The Calcutta Gazette

WEDNESDAY, JULY 7, 1920.

NOTICES TO MARINERS.

THE following Notices are republished for general information.

Reproduction of Portion of Chart N° 3616.

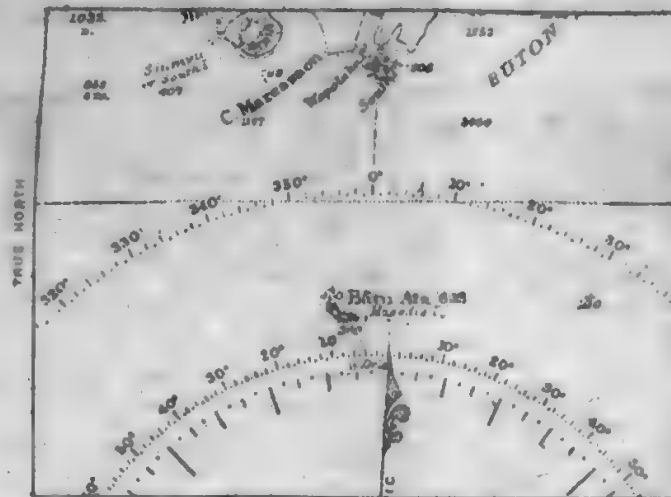
Charts affected.—No. 3616, Tomori gulf to Salayar strait.
 „ 942a, Eastern archipelago—sheet III.
 „ 2759a, Australia—northern portion.
 „ 1233, China sea.
 „ 2483, Atlantic and Indian oceans, &c.
 „ 2683, Pacific ocean.
 „ 2937, Oceanic soundings, Indian and Western Pacific oceans.

Reproduction of Portion of Chart N° 3616.

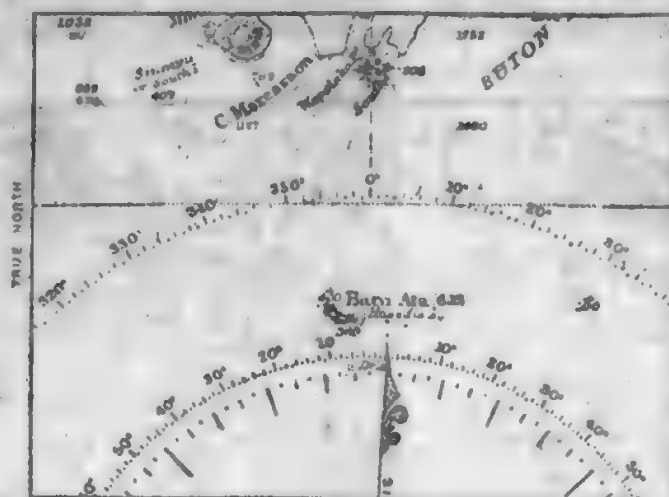
Charts affected.—No. 3616, Tomori gulf to Salayar strait.
 „ 942a, Eastern archipelago—sheet III.
 „ 2759a, Australia—northern portion.
 „ 1233, China sea.
 „ 2483, Atlantic and Indian oceans, &c.
 „ 2683, Pacific ocean.
 „ 2937, Oceanic soundings, Indian and Western Pacific oceans.

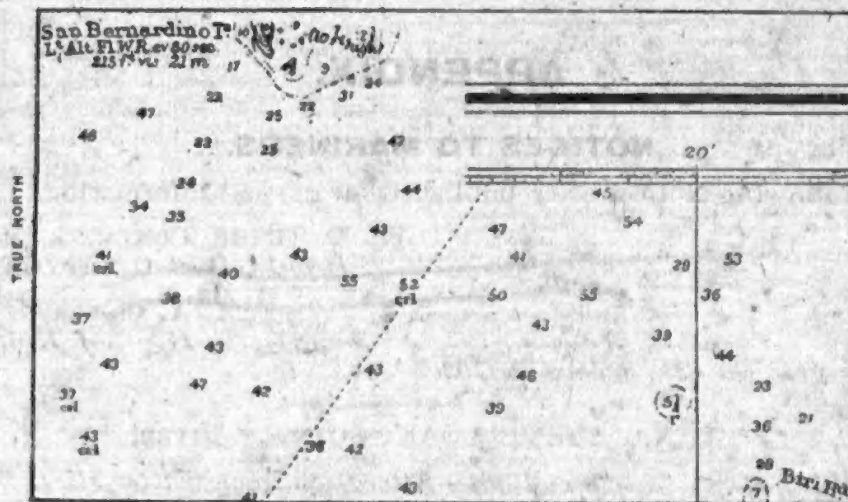
Details.—The accompanying reproduction of portions of chart No. 3370 show the necessary amendments with regard to shoals in the vicinity of San Bernardino islets and Kabuan island.

Charts affected.—No. 3370, San Bernardino strait and approaches.
